RE: United Power Stonehouse Substation Conditional Use Permit – RCU2025-00008 Submittal 2

Ulteig on behalf of United Power, Inc. respectfully delivers this second submittal for Stonehouse substation Conditional Use Permit application RCU2025-00008.

Adams County Comments and United Power/Ulteig Responses

Fencing Details

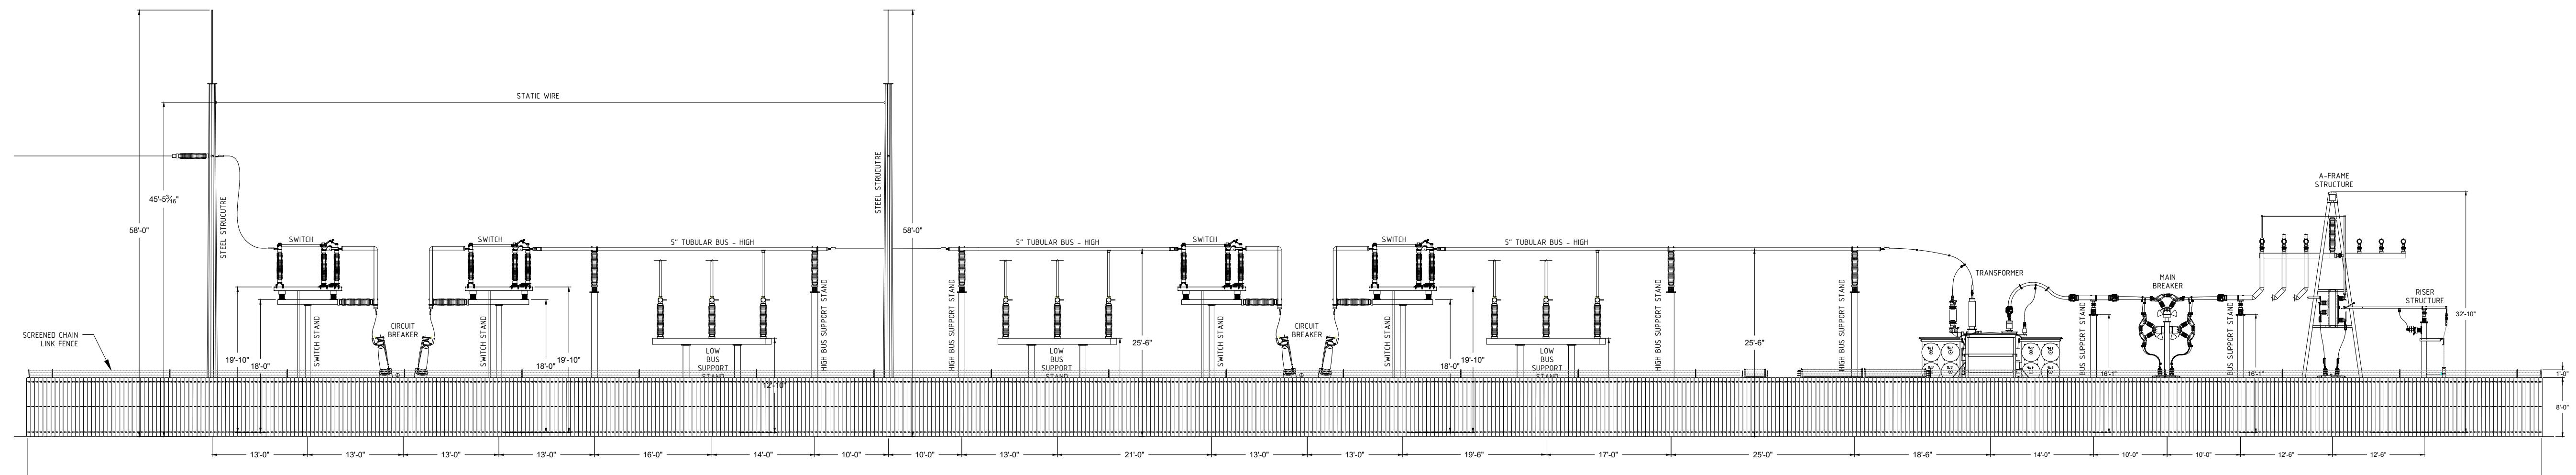
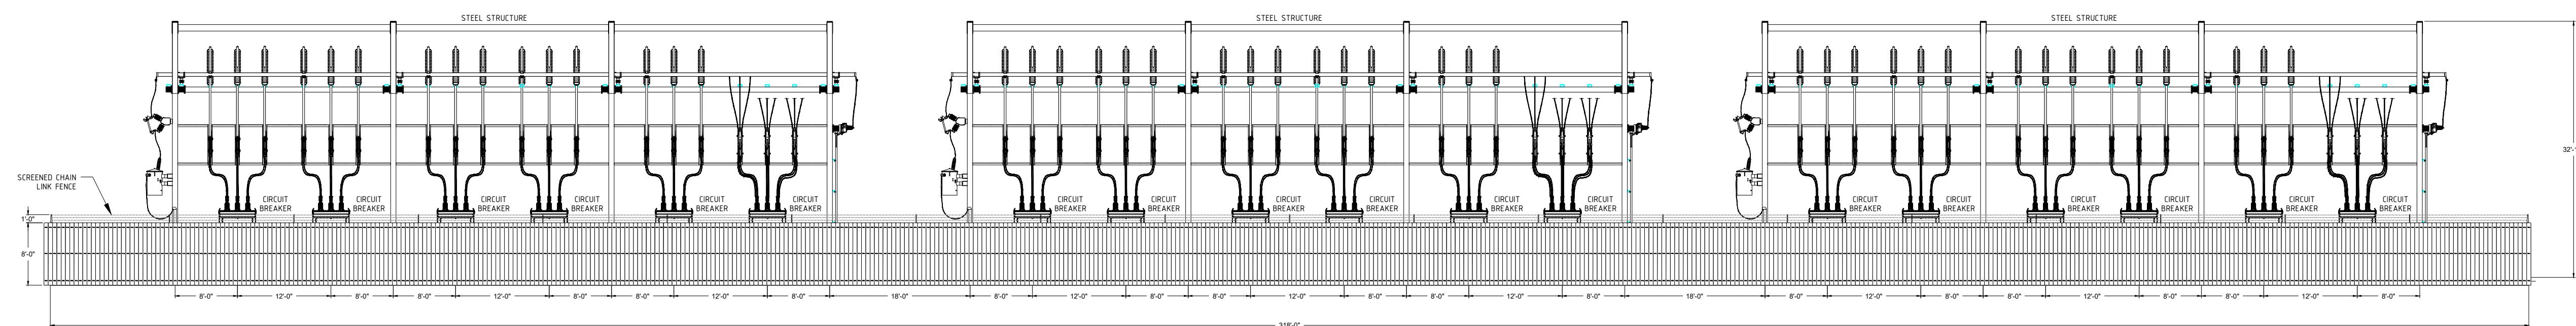
PLN04: Will the chain link fence have inserts? Please describe in further detail. Staff prefers a solid screen wooden fence.

Response: United Power plans to install two fences. The inner fence will be an 8-foot chain link security fence with 1-foot of barbed wire on top. The outer fence will be an 8-foot decorative wooden fence. A Variance application for fence height was submitted on 11/11/2025 (PRA2025-00009 & VSP2025-00054).

Figure 2 – Existing Conditions

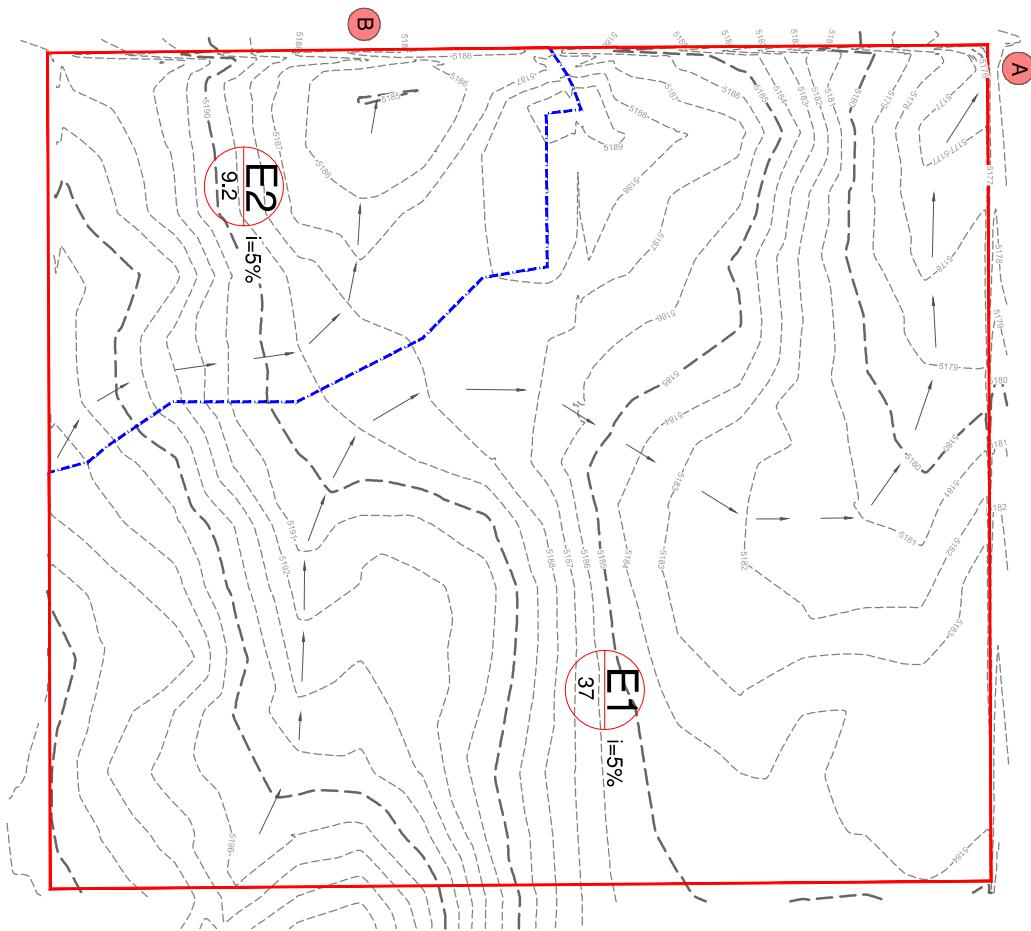
ENG4: Submit a preliminary drainage report. The applicant is proposing to install over 3,000 square feet of impervious area on the project site. A drainage report and drainage plan in accordance with Chapter 9 of the Adams County Development Review Manual are required to be completed by a registered professional engineer and submitted to Adams County for review and final approval. Full drainage engineering designs and reports are not required with the change of use.

Response: Noted. Preliminary drainage report and plan attached hereto.

Figure 3 – Proposed Conditions

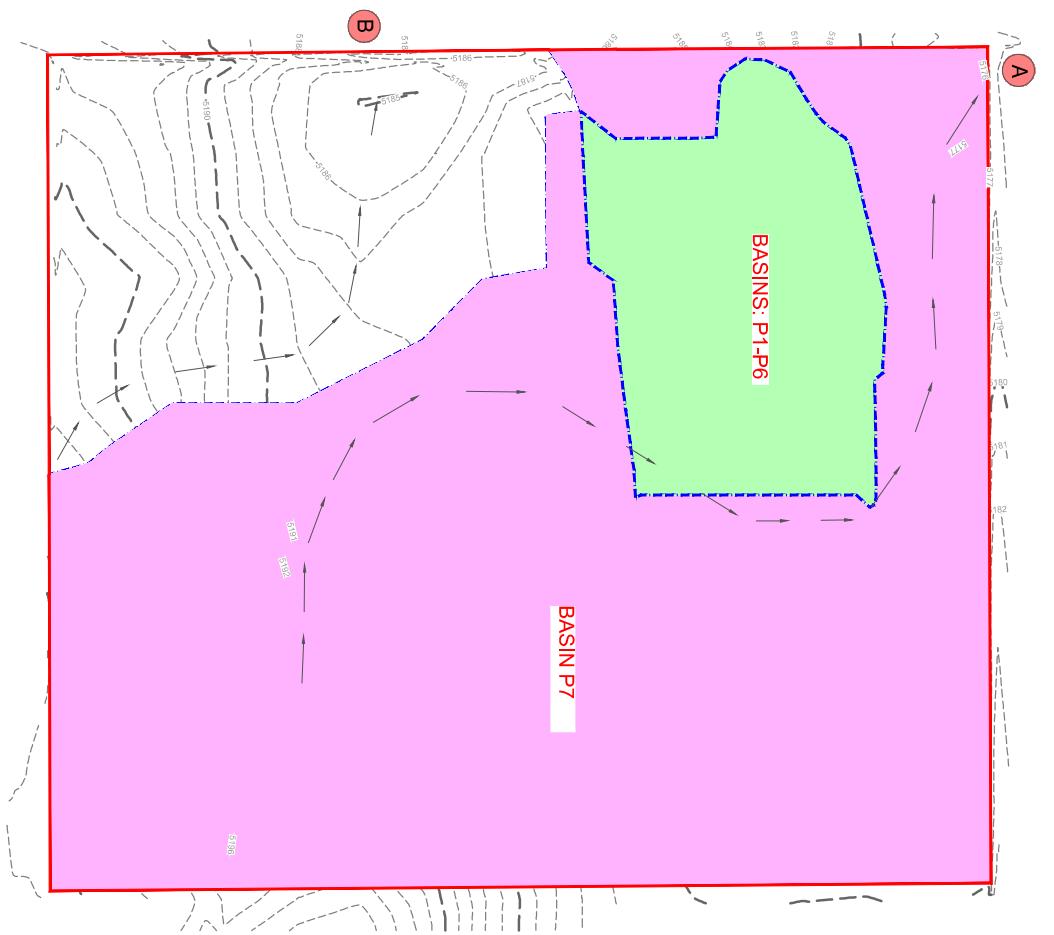
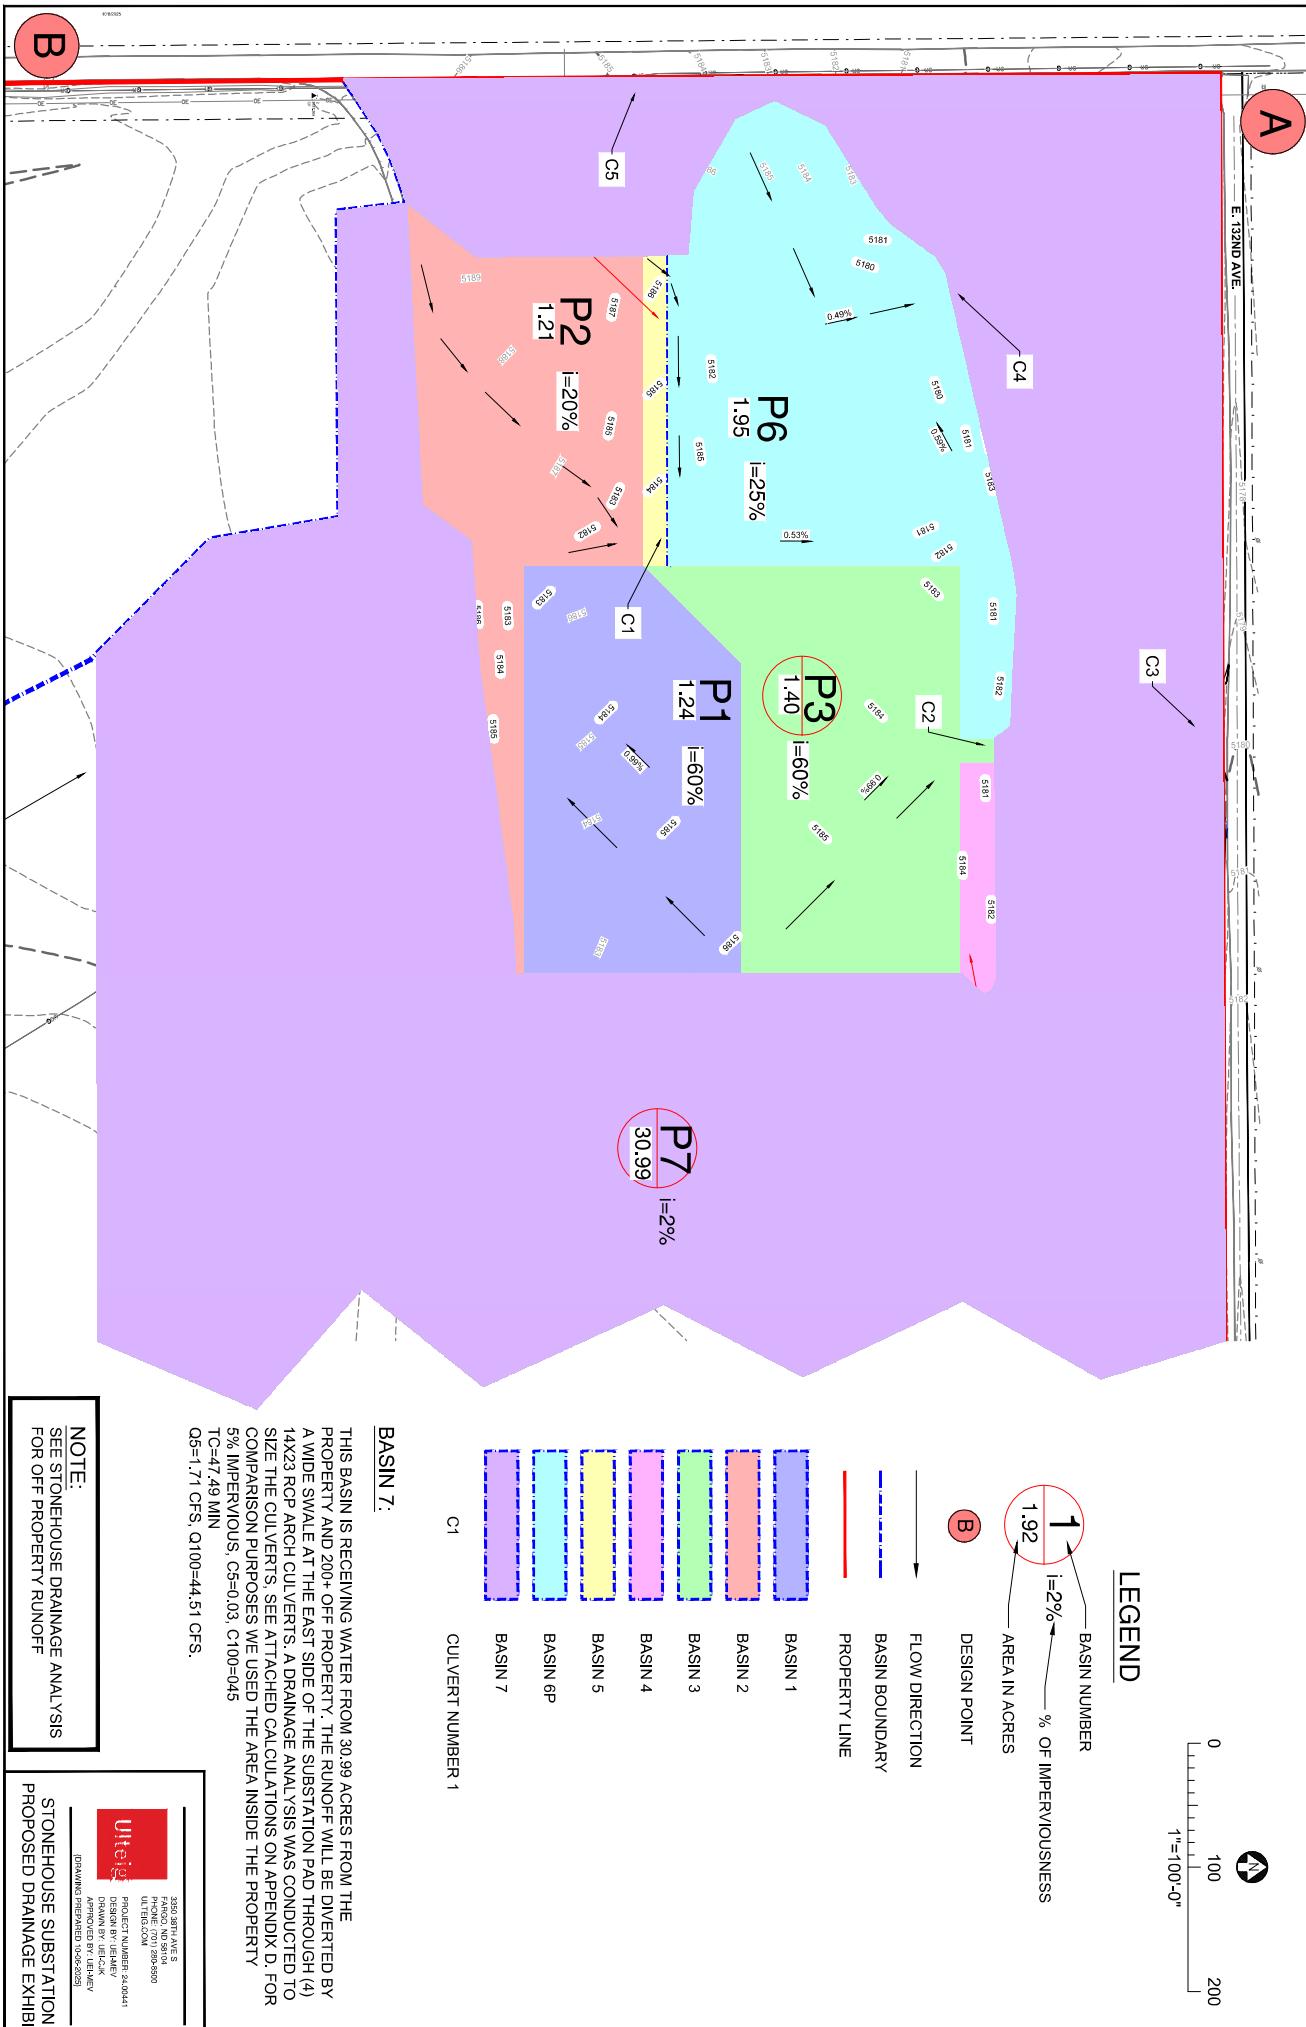
ENG6: If the applicant is proposing to install over 3,000 square feet of impervious area on the whole project site, a drainage report and drainage plans in accordance to Chapter 9 of the Adams County Development Review Manual, are required to be completed by a registered professional engineer and submitted to Adams County for review and final approval. Drainage design shall show no adverse off-site impacts on neighboring properties or the public ROW.

Response: Noted. Preliminary drainage report and plan attached hereto.
